ADDENDUM 2 – JOB 8

TO: All prospective bidders on Project ROM-0300(134), Job No. 8 scheduled for the July 13, 2018 bid opening.

To: All prospective bidders on Project ROM-0300(134), PCN 21834
Ward and Mountrail Counties; Road Inslope Repair and Permanent Stabilization: Job 8,
scheduled for July 13, 2018 bid opening.

Plan Revisions: ROM-0300(134), PCN 21834

Revised	7/10/18	STATE	PROJECT NO.	SECTION NO.	SHEET NO.
		ND	ROM-0300(134)	8	1

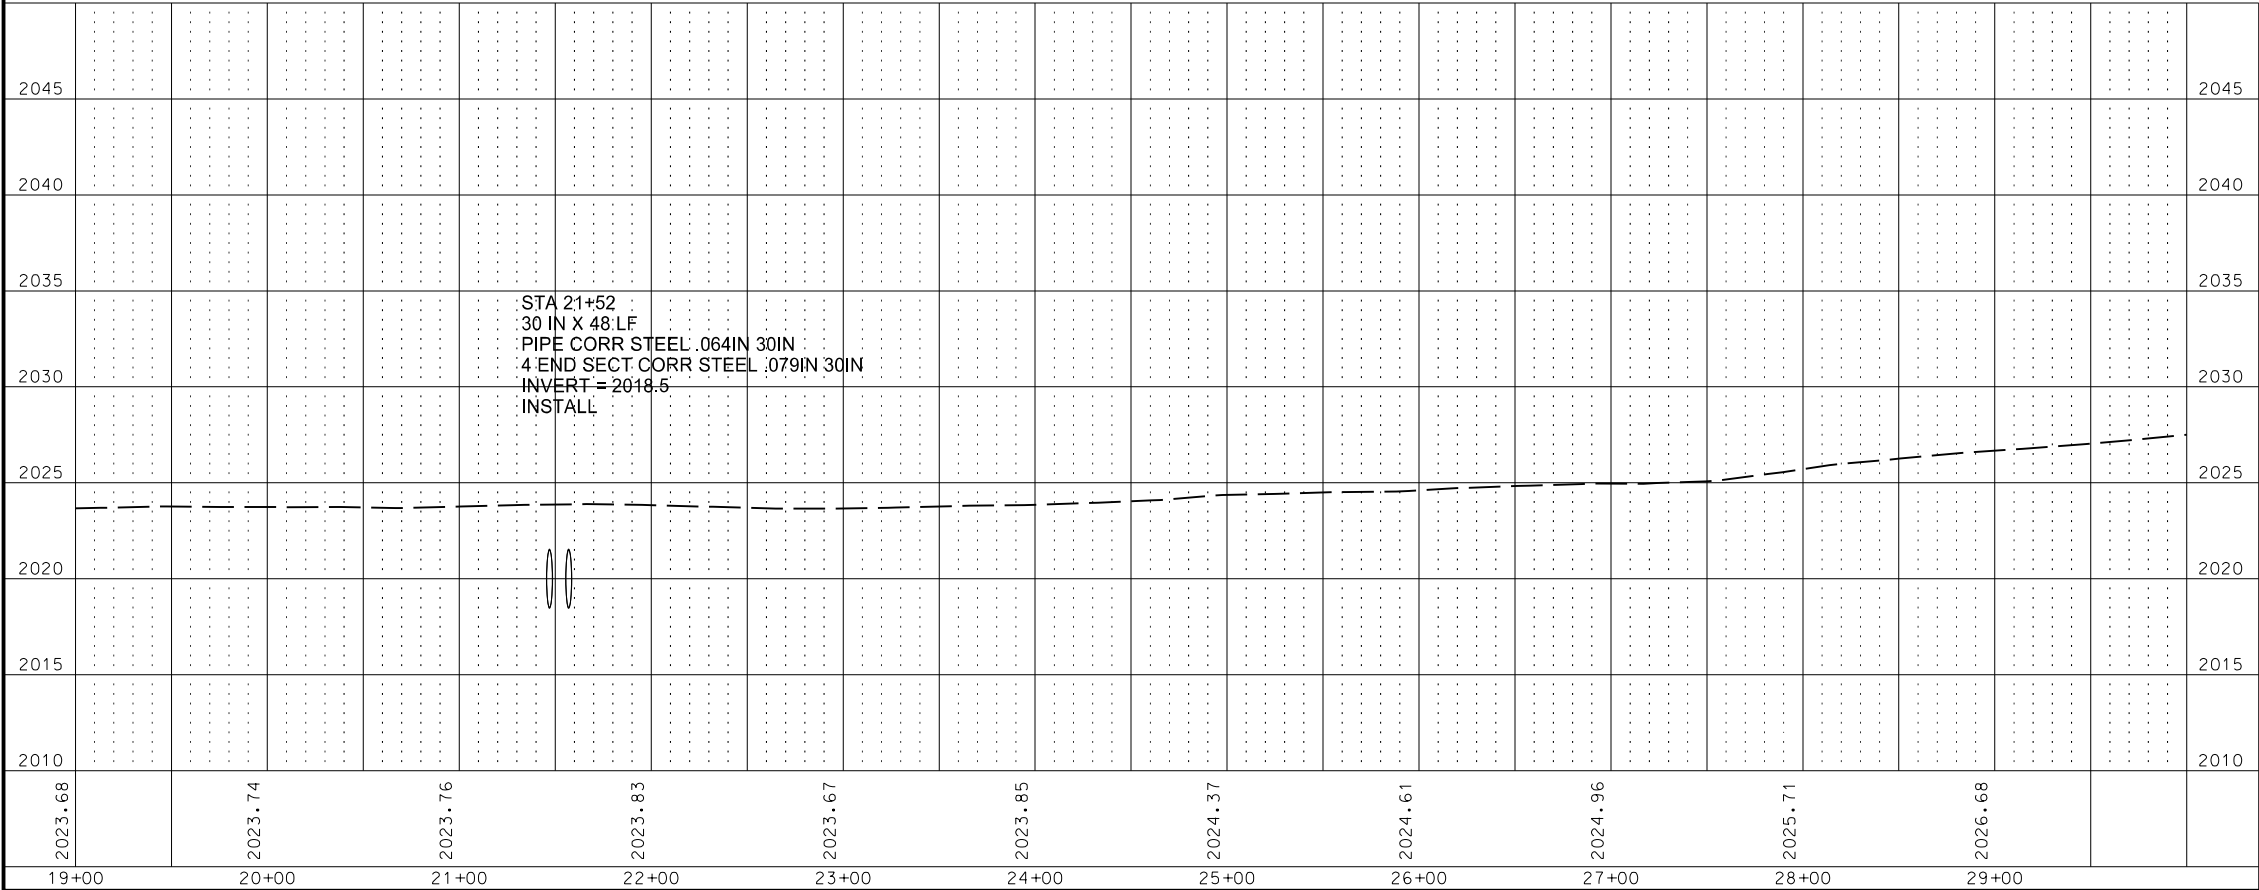
“Do not install Geosynthetic Material Type R1 as shown on Standard Drawings D-714-25, D-714-26, D-714-26M & D-714-28”.
3. Sec 8 Sheet 1: Removed Spec 709 Code 0151 Geosynthetic Material Type R1.
4. Sec 60 Sheets 1-8, 10-20, 22-27 & 29-31:
Removed Spec 709 Code 0151 GEOSYNTHETIC MATERIAL TYPE R1 from sheets.

TRANSVERSE MAINLINE PIPE INSTALLATION DETAIL
MULTIPLE PIPES 4 FEET OR LESS BELOW TOP OF SUBGRADE

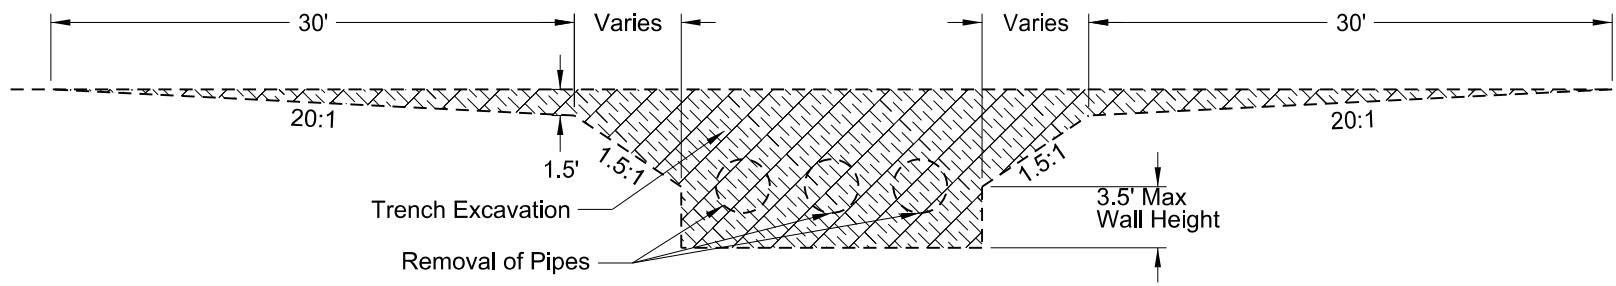
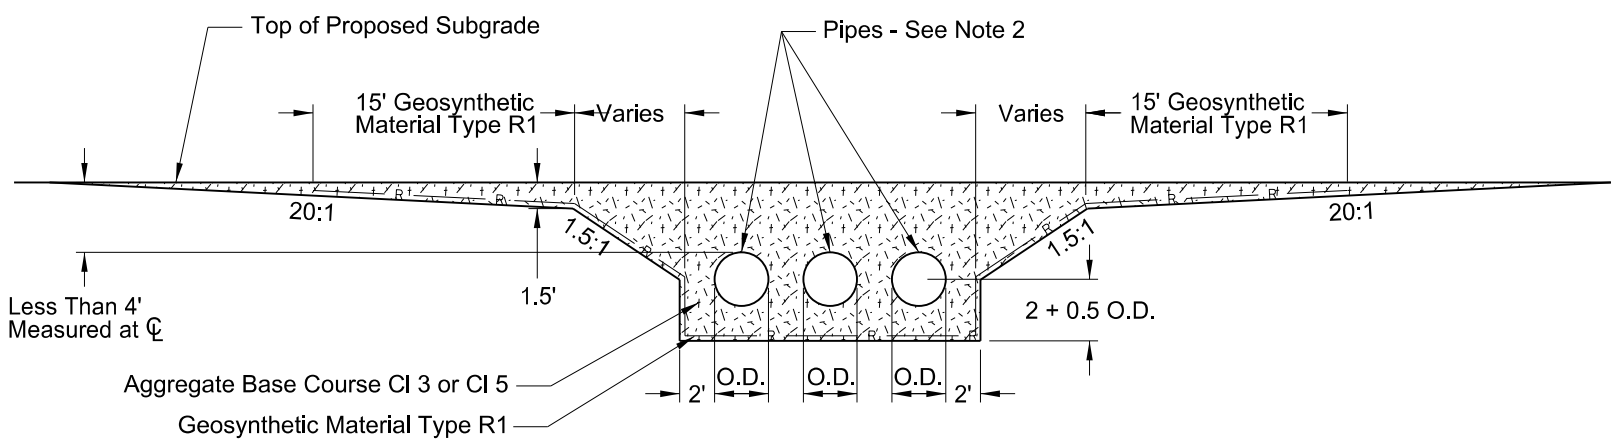
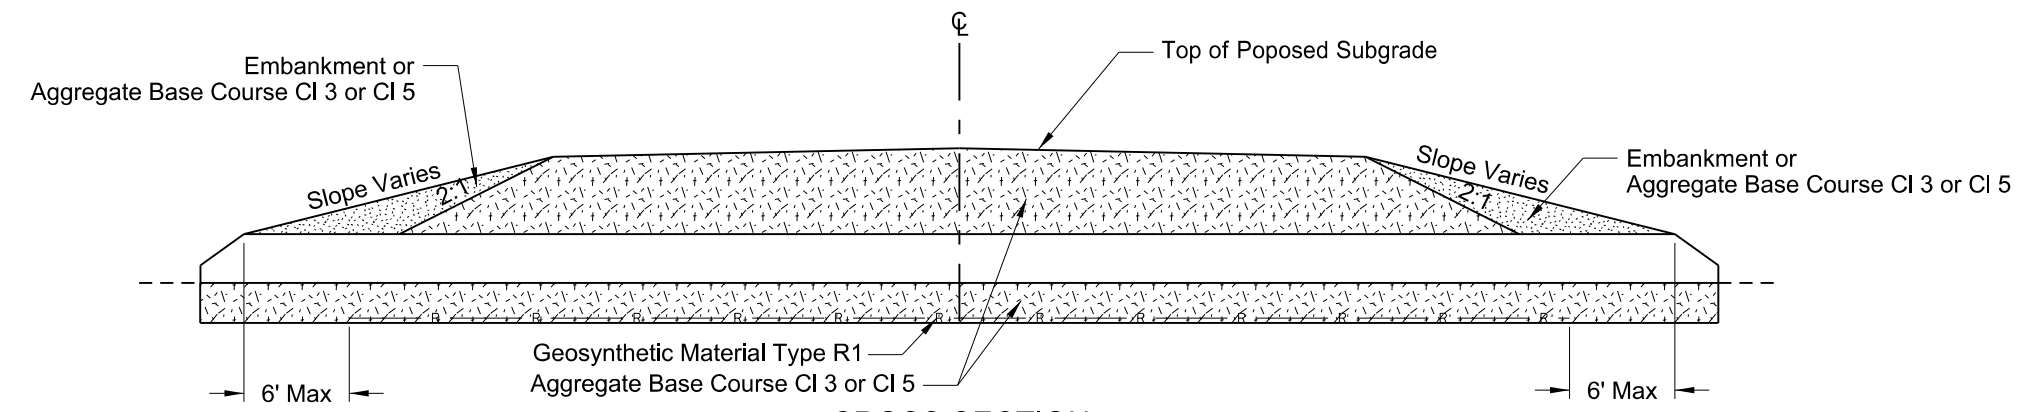
1. Sec 2 Sheet 1: Removed Standard Drawings D-714-25M & D-714-28M. Added Standard Drawing D-714-26M.
2. Sec 6 Sheet 3: Added Plan Notes to 714-P01 PIPE INSTALLATION.
